TOWN OF CARMEL
ENVIRONMENTAL CONSERVATION BOARD

ENVIRONMENTAL CONSERVATION BOARD AGENDA

FEBRUARY 1, 2024 – 7:30 P.M.

Project: C:\pss\23-13\SPIELMAN STORMWATER SITE PLAN.dwg
 Date: 09/20/22 Sheet: C-1
 Scale: AS NOTED

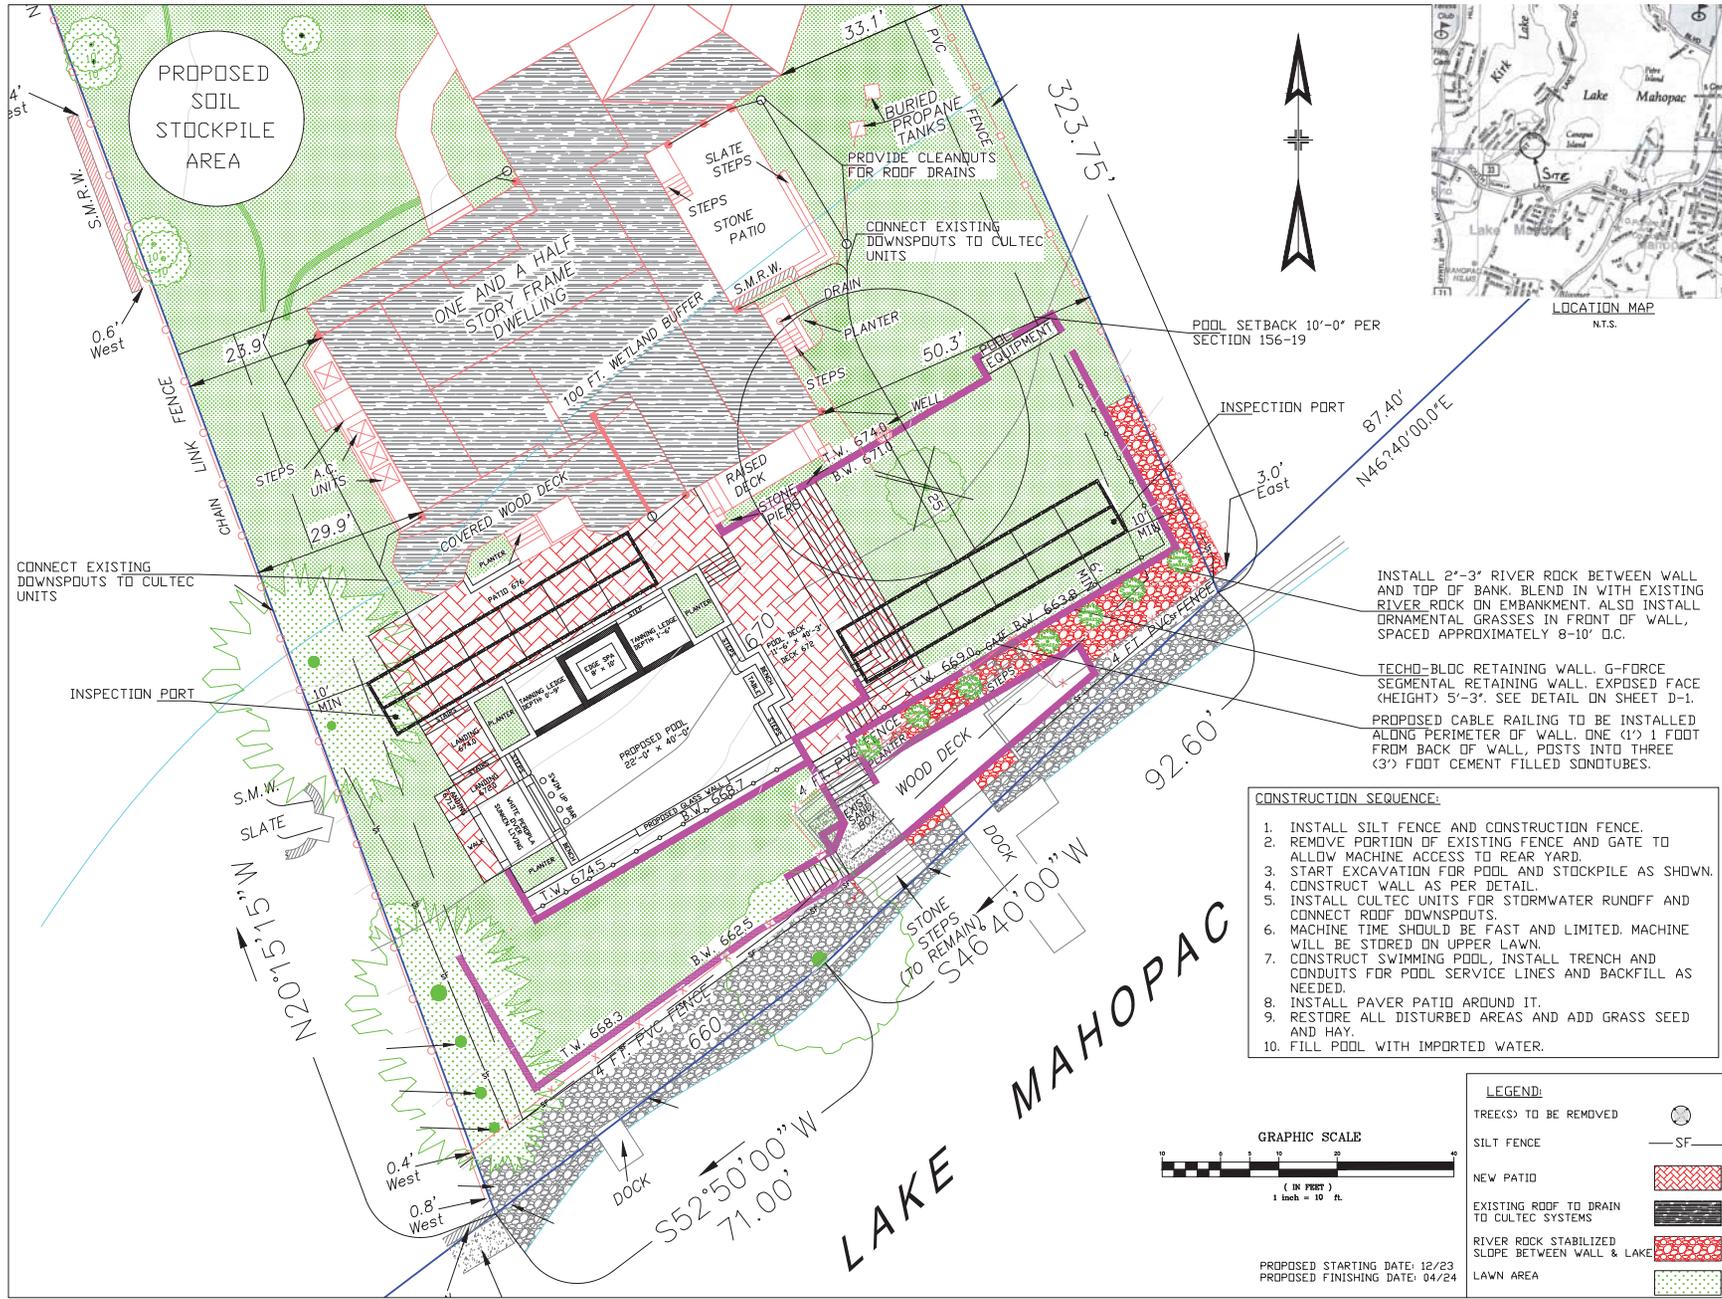
- Area of disturbance: 3,750 s.f.
- Area of imperviousness: 1,600 s.f.
- States that no terrain with slopes of 10% or greater exist on the site. Existing Slopes in the rear of the property average 17.7% +/-.

- Rain gardens are designed for a 2-year storm (3.1").
- Rain gardens (up gradient) are within 18 ft of existing well. Not an approved practice.
- Plan doesn't show existing stone patio and stairs to basement. Rain garden proposed over them.

- Plan doesn't show existing propane tanks (2) in rear when garage addition built
- Pool plan is not what is being proposed on Keeler or Econom plans
- With grade differential of approximately 4 ft. from rear of house to rear of the pool patio, there would be the necessity for retaining walls or expanded grading (limit of disturbance).

- Roof leaders are not connected to drywells. They discharge to the rear/lake. Determined during construction.
- Location of pool equipment is area of a/c units. No room for equipment.

- Area of disturbance: 4,800 s.f.
- Area of imperviousness: Not listed
- No mention of existing slopes in pool area.
- No stormwater provided on plan.
- With grade differential of approximately 8 ft. (676 to 668, from pool deck to ground level), a 2-foot stone wall doesn't work. There would be the necessity for retaining walls or expanded grading (limit of disturbance).
- Plan doesn't show existing stone patio and stairs to basement. Rain garden proposed over them.
- Plan doesn't show existing propane tanks (2) in rear when garage addition built.
- Location of pool equipment is area of a/c units. No room for equipment.

- Area of disturbance: 4,876 s.f.
- Area of imperviousness: 3,471 s.f.
- Existing slopes in pool area average 17.7%
- Cultec Stormwater systems are designed for a 25-year storm (6"). They collect approximately 85.4% of roof runoff and filters it before getting to lake.
- Cultec system is down gradient and 25 ft. from existing well.
- Plan shows propane tanks (2) in rear when garage addition built.
- Pool plan accurate plan from Prestige Pools and Patios.
- Grading has been worked out with Techo-Bloc retaining wall. Wall has less than a 6 ft. exposure and will have ornamental grass planted in front. Retaining wall provides buffer between lawn/pool area and lake for filtration.
- Roof leaders are connected to Cultec system and filter roof runoff into ground via gravel and sandy soils.

G-FORCE BLOCK REINFORCED WALL CROSS SECTION

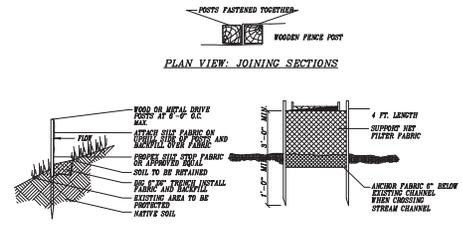
Also please advise the applicant that any wall over 5' in height must be designed and certified by a structural engineer and that a separate submittal for the file should be provided.
